2 Chifley Square Urban Design Addendum

The Draft Development Control Plan (DCP) for the planning proposal for 2 Chifley Square, Sydney proposes different tower massing to the proponent's lodged planning proposal and supporting studies. This addendum describes the differences, the reason for the change and briefly outlines where environmental impacts are different.

Axonometric view from the south-west

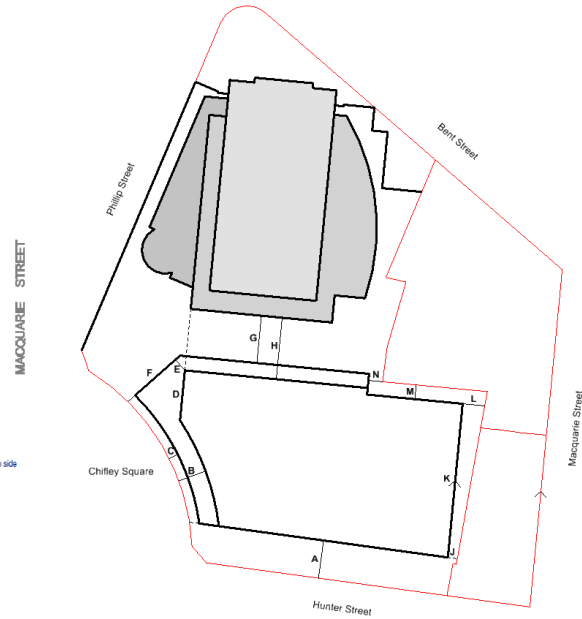
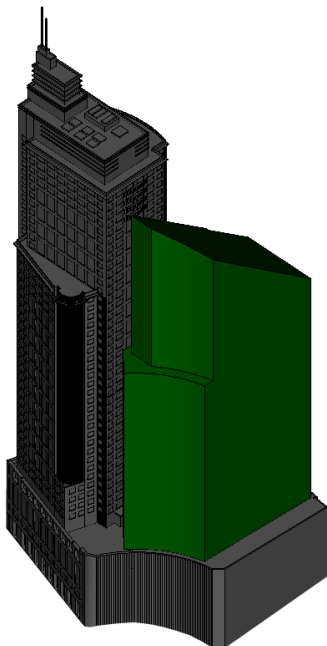
The larger envelope extends up to 120m above ground level. Above this level the setback to Chifley Square and the separation from the existing building increase.

The proposed DCP envelope volume is slightly larger than the lodged.

- has an increased setback to Hunter street from 4m to 8m
- is parallel to the curved geometry of the Chifley square with a smaller setback in the lower part of the control envelope and a wider presentation to the square and greater setback in the upper part
- includes a setback to the eastern side boundary
- has reduced separation to the existing tower and geometry that aligns with the boundaries and geometry of the existing tower.

These changes have been made in response to concerns raised by the City's Design Advisory Panel (DAP):

- In summary, given the close alignment between the lodged envelope and the lodged reference design, concern that the envelope needs to be expanded to allow greater flexibility for design innovation that provides an appropriate urban response.

- concern that the curved shapes of the envelopes may lead to a similar form as with the reference design, and are not necessarily contextual with the rest of Hunter Street and the existing Chifley tower.

- concern also that the curved alignment to south boundary of the envelope allows potential tower alignment too close to Deutsche Bank Place tower across Hunter St. Also and the view to sky and separation is critical here, and an alignment parallel to Hunter St is a better urban response.

- belief that more built form could move closer to the existing Chifley tower as that tower separation is less important than Hunter Street.
- the tower envelope should be set back a minimum of two metres and also be parallel to Macquarie Street.

- noting that the existing built tower modulates as it rises with stepped tower form (with three principal datums), the proposed envelope should facilitate similar stepping.

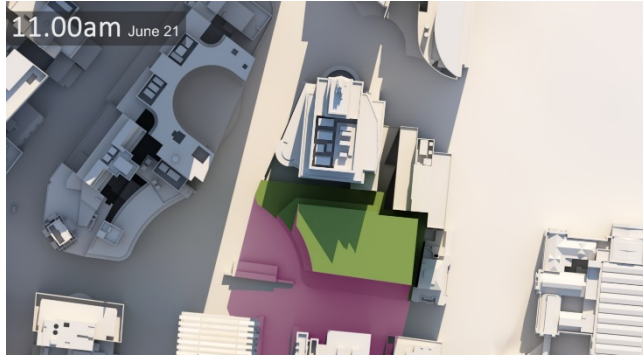
The proposed planning envelope has the same overall height as the lodged envelope. Both sit below the Domain sun access plane and so have similar overall effects.

The proposed planning envelope extends further north-west than the lodged envelope. This means that a building could locate closer to the square in this location and cast some additional shadow on the square in the summer months. This effect has been balanced by the increased setback to Hunter Street which will allow more early morning sun into Hunter Street between the equinoxes.

There are very minor overshadowing changes to public places in winter because the existing building and neighbouring tall buildings cast shadows over the squares and streets.

The diagrams below show shadow cast by the proposed envelope in pink/purple. Note that it is not all additional overshadowing.

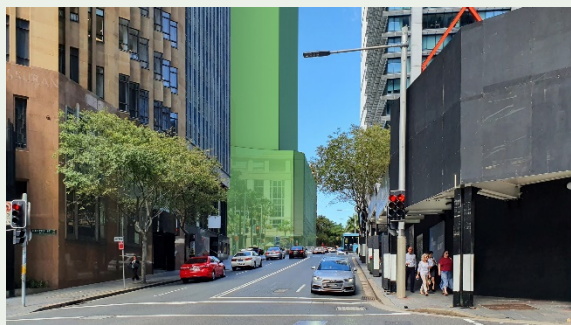
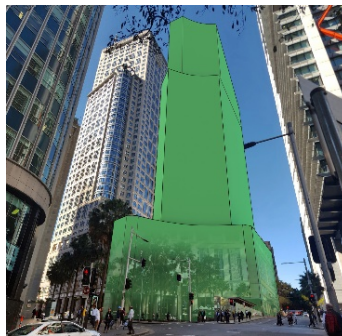
The changes do not create significantly different view effects.

The main change is that the proposed planning envelope will block more of the view of the existing Chifley Square tower viewed from the south along Phillip Street and Elizabeth Street where it rounds the corner into the square. This additional visibility of the proposed tower is acceptable.
